"Cross-fire" solution for PSL beam
ECR E1300676

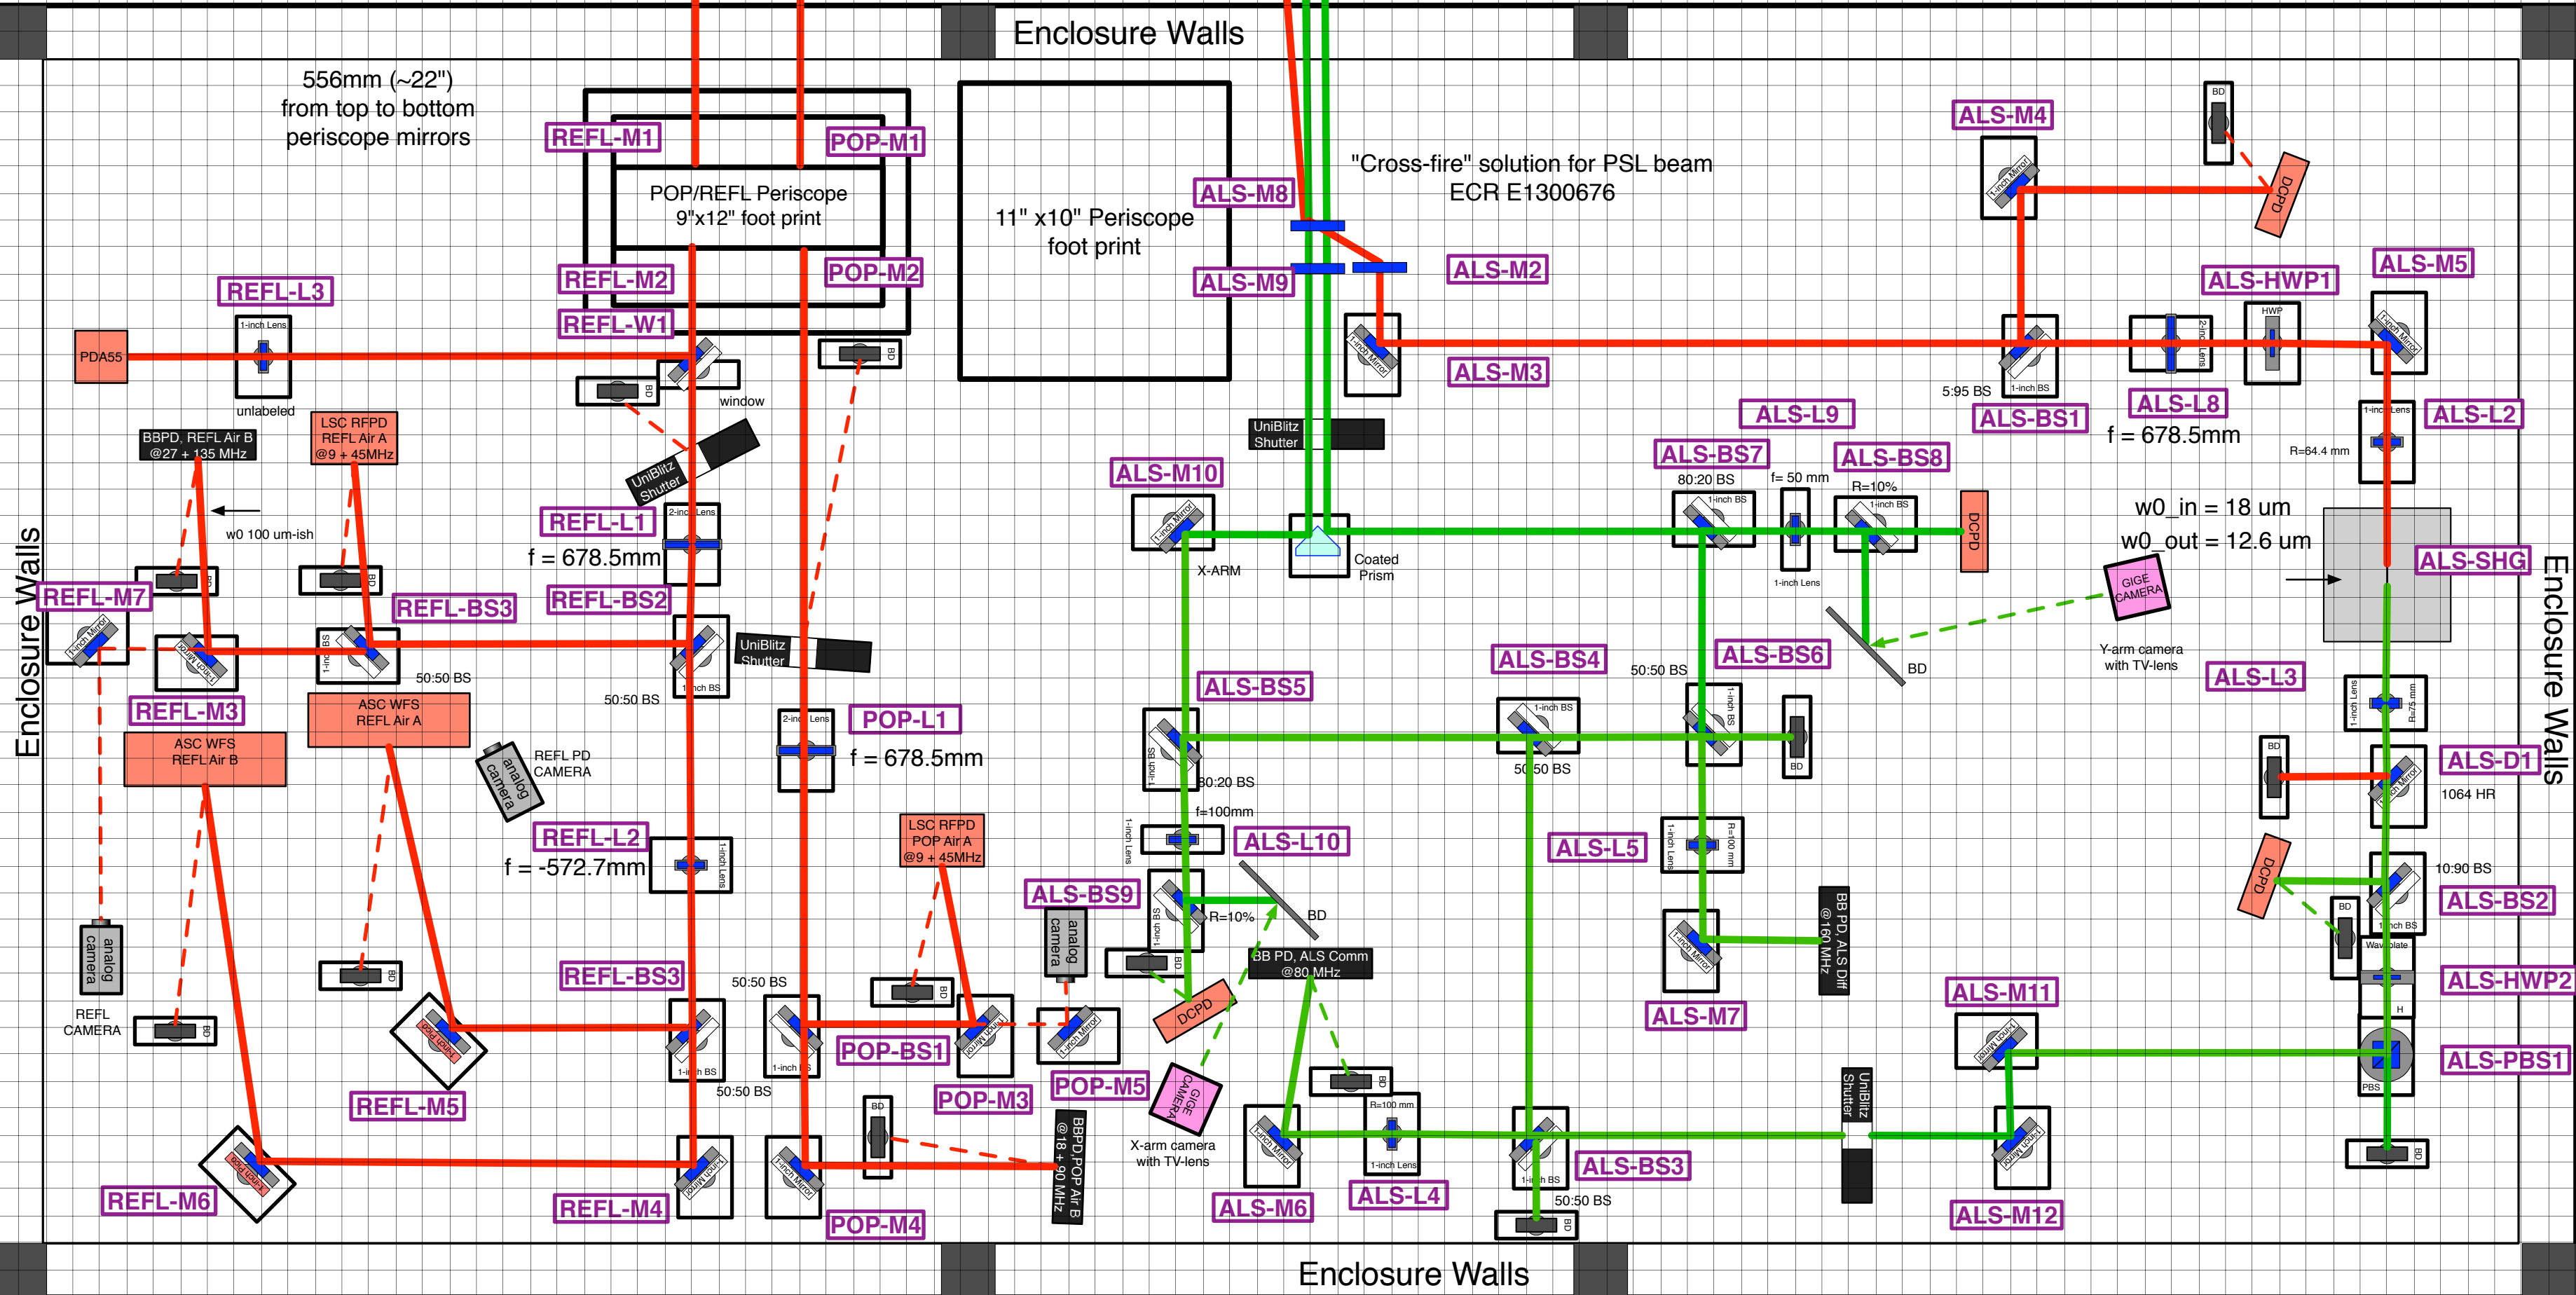
556mm (~22")
from top to bottom
periscope mirrors

POP/REFL Periscope
9"x12" foot print

11" x10" Periscope
foot print
